Review of the Muskrat Falls and Labrador Island HVdc Link and the Isolated Island Options

Review of the Muskrat Falls and Labrador Island HVdc Link and the Isolated Island Options

Prepared for:
Hon. Jerome Kennedy, Q.C.
The Minister of the Department of Natural Resources
Government of Newfoundland and Labrador

Prepared by:
Manitoba Hydro International Ltd.
211 Commerce Drive
Winnipeg, Manitoba R3P 1A3, Canada
www.mhi.ca

Figure 8: Typical HVdc Transmission Guyed Tangent Structures which comprise approximately 85% of the towers in the Labrador-Island HVdc transmission line

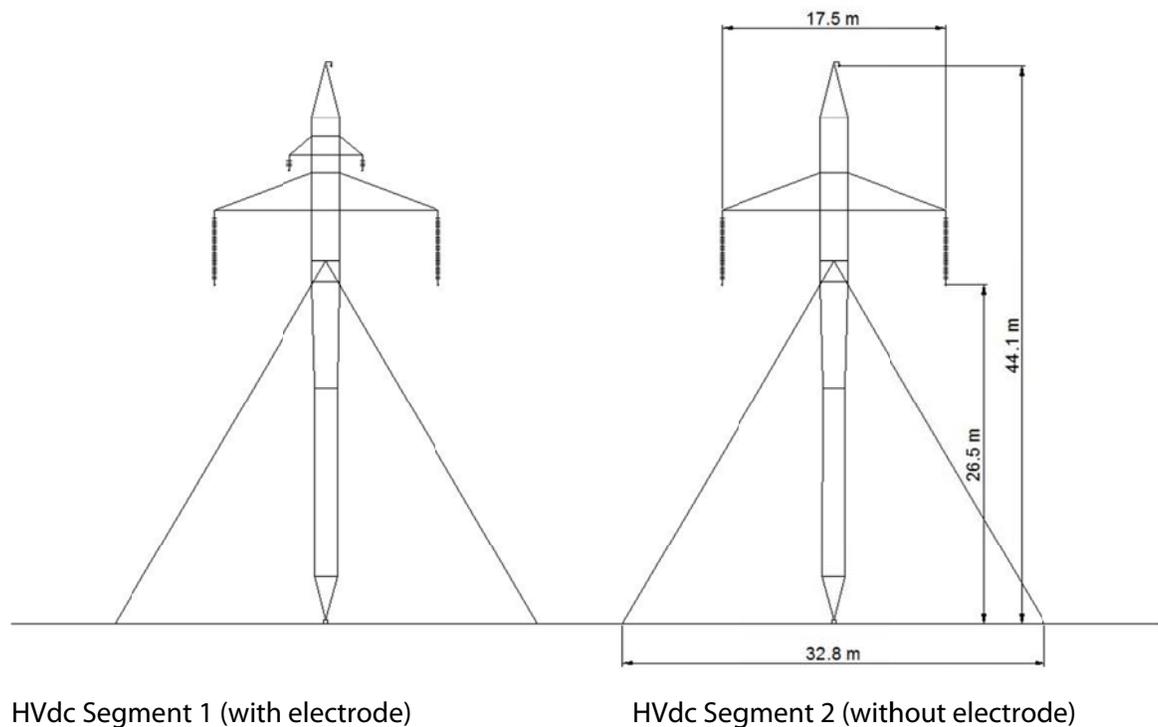
Engineering work is in progress to complete the detailed design for the HVdc line. Nalcor has defined 12 structure families, with a total of 25 structure types, required to economically construct the line. Wherever possible, an effort was made to use common structures in the various loading zones in an effort to minimize the number of unique, custom structures which mitigates design and construction cost.

Nalcor's design controlled the structure loading from the various ice-and-wind loading combinations by reducing or increasing the ruling span in the 11 weather-zone regions. Generally, as the loading increased, the design ruling span and conductor tension was

Figure 9: Climatic Ice Loads along the HVdc Transmission Line Route compared to the CSA Standard 1:500-year return period limit

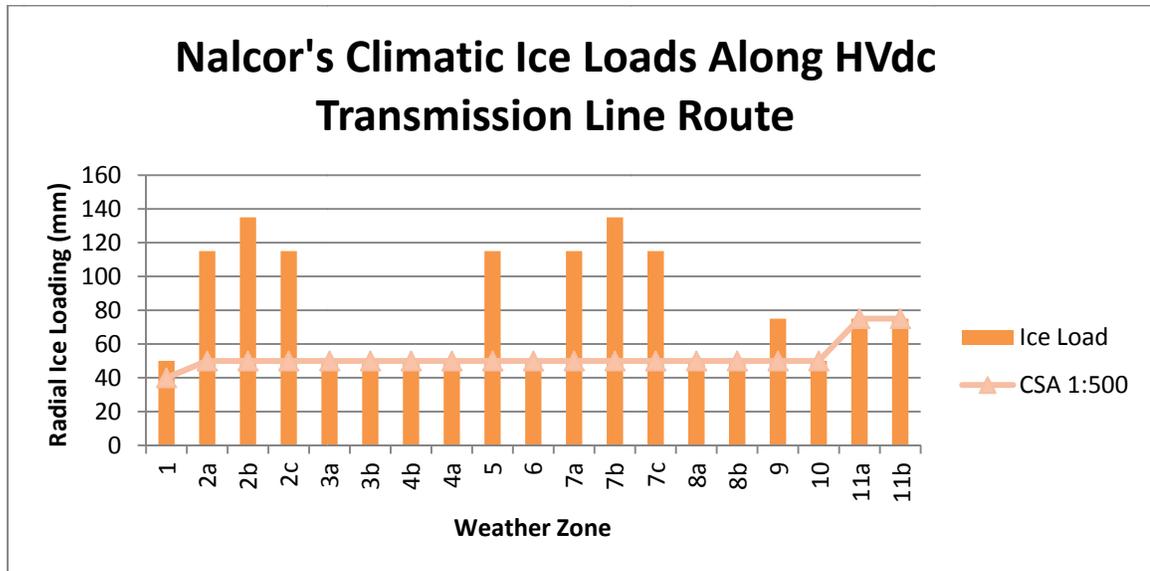
Nalcor’s research studies to define the climatic loadings along the transmission line route were based on 50 years of data, as outlined in the document “Muskrat Falls Project – Exhibit 97, Appendix A Revision 1”. The climatic loadings for each line section are approximately equivalent to the climatic loadings calculated assuming Canadian Standards Association (CSA) 1:500 year-return period.

MHI notes that CAN/CSA C22.3 suggests a greater reliability of design to 1:150-year or 1:500-year return periods for lines of voltages greater than 230 kV which are deemed of critical importance to the electrical system. It is MHI’s opinion the ±350 kVdc and 315 kV ac lines proposed for the Lower Churchill Project be classified in a critical importance category due to their operating voltage and role in Nalcor’s long term strategic plan for its transmission system and be designed to a reliability return period greater than 1:50 years.
